March 6, 2023

To: Wild Blue Community Development District c/o Chesley 'Chuck' Adams Jr.

Subject: Hurricane Ian Retaining Wall Impacts Assessment

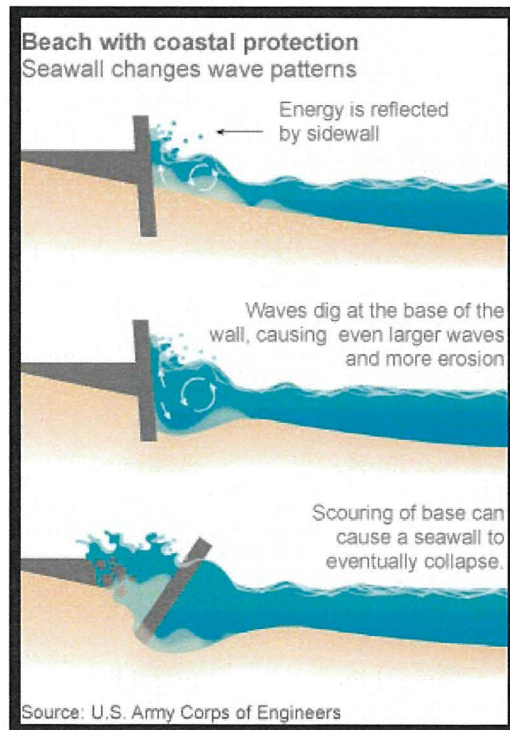
The next form of failure was loss of the deadmen. In the photo below the deadmen anchoring the retaining wall failed. It is likely that the saturated soil condition, either from rain fall, inundation from wave overtopping or both, eliminated the holding power of the soil in front of the face of the deadman, allowing them to move in the waterward direction. This then allowed the retaining wall to fall over rotating about the toe or bottom of the panels. There was not sufficient soil on the passive (waterward) side to counter the loss of the anchors. This was the most common failure mode. The areas that exhibited the most destruction were at the north end directly fronting the open waters of the lake. In some instances, particularly with the failure shown below, there was overtopping of the stormwater berm from the land side and discharge to the backside of the retaining wall, further saturating the soil and reducing the effectiveness of the dead men.
